U.S. ROUTE 5 HARTFORD AVENUE

| PROJECT NAME: HARTFORD | PLOT DATE: 3/13/2008 |
| PROJECT NUMBER: RS 0113(40) | DRAWN BY: T. DUGUAY |
| PROJECT LEADER: | SHEET 7 OF 14 |

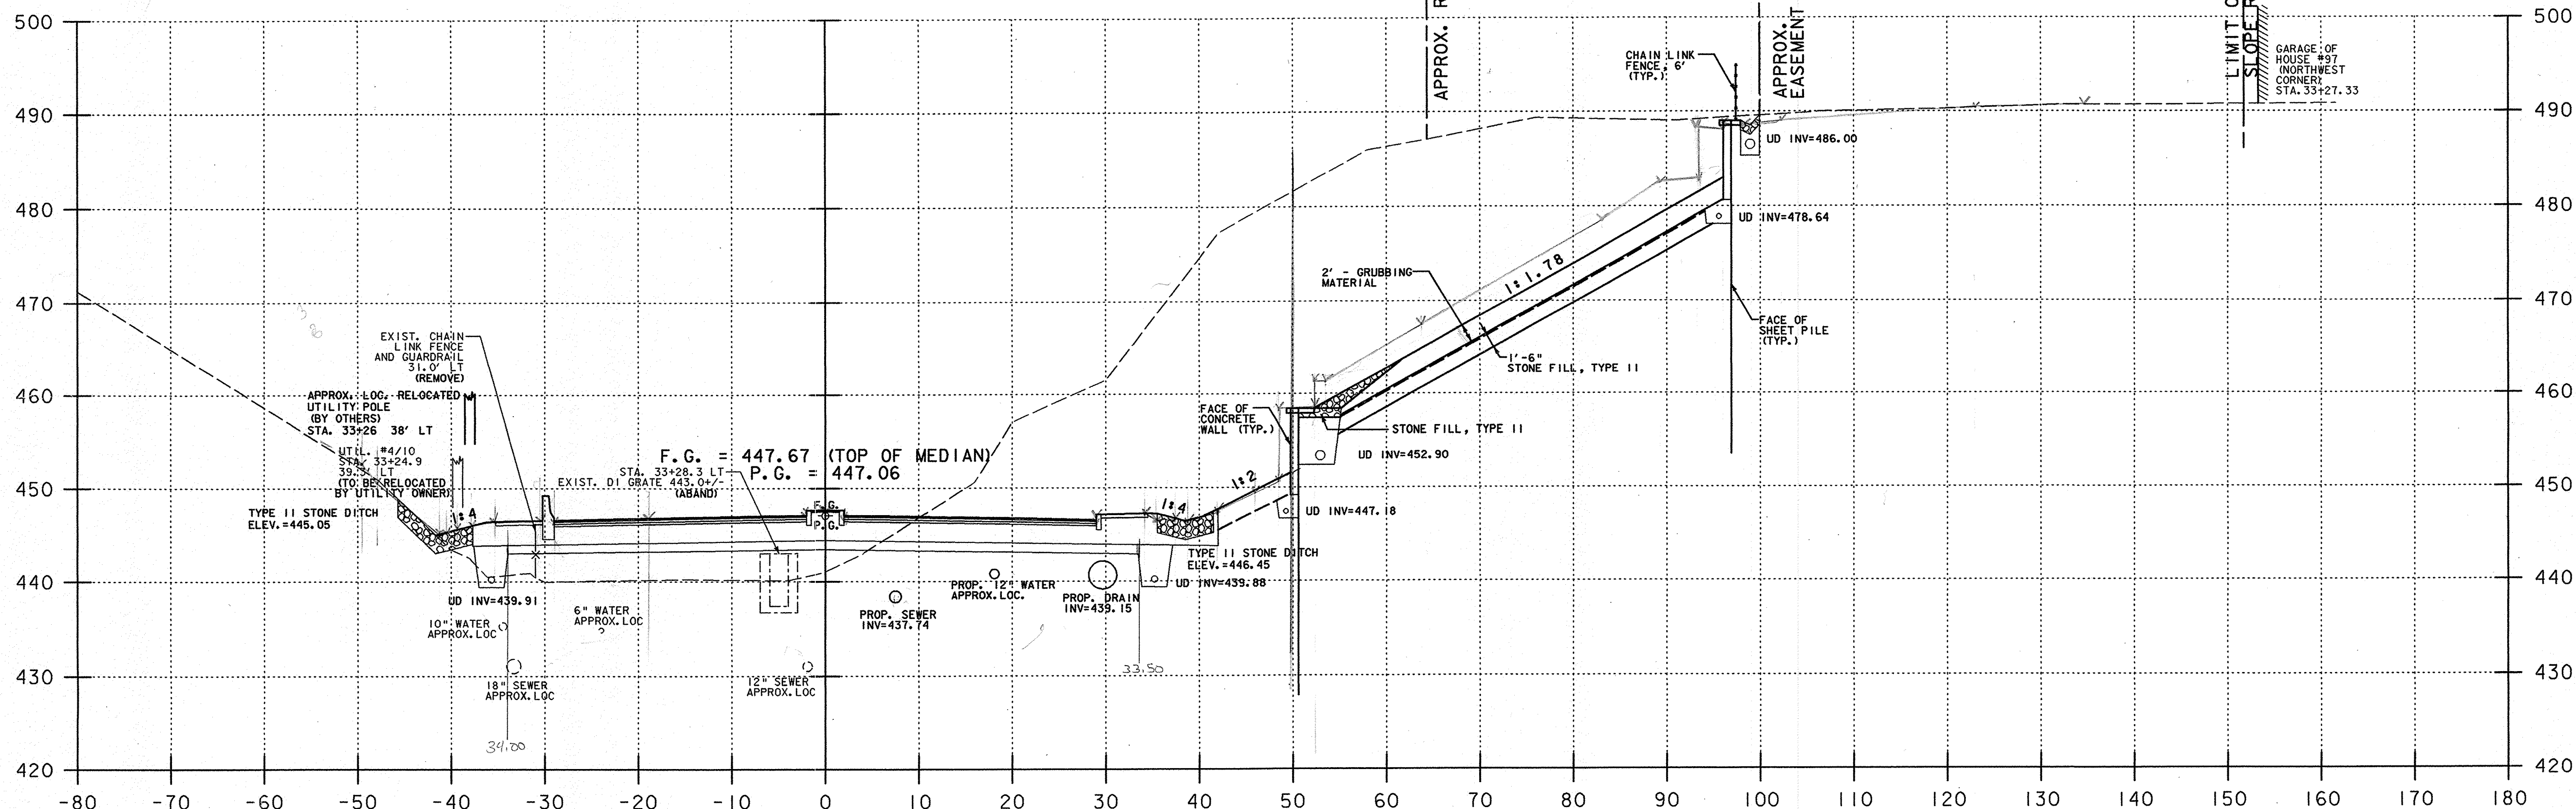
Common Excavation
 DITCH LF = 12.4 LF
 ROADWAY SILLS = 76.22 SF
 LANDSCAPE RT 8.75x2 = 17.5 SF
 Common = 77.97 SF
 03/01/11

SUBBASE 178.28 BL 3/23/10
 SUBBASE 193.59
 SAND 87.5 BL 3/23/10
 F.G. = 83.0 LF RCD 1/24/11
 03/01/11

Common Excavation
 DITCH LF = 21.55 LF
 ROADWAY SILLS = 79.30 SF
 LANDSCAPE RT 8.75x2 = 17.5 SF
 Common = 806.0 SF
 03/01/11

SAND 67.55 BL 3/23/10
 SUBBASE 173.32 RCD 1/10/11
 155.0 SF
 03/01/11
 F.G. = 79.5 LF RCD 1/24/11
 03/01/11
